SB, New throttle wire and lever, BG 245, 2024-03

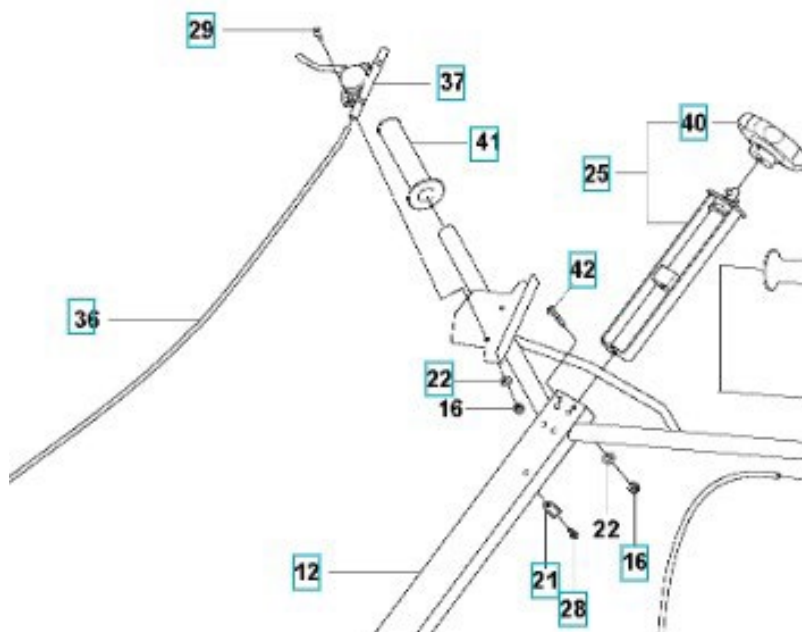
Due to the subcontractor having stopped the production of some components, a new throttle wire and lever has been introduced. These are not interchangeable with the old ones. The machines before the listed serial numbers in the *Affected units* table require a retrofit kit to be ordered if a throttle wire or lever is to be replaced.

In case an old type throttle cable pos.36 (594252001) or a throttle lever pos.37 (594224101) needs to be replaced with the new type, a retrofit kit should be ordered.

548497801 – Retrofit kit for BG 245.
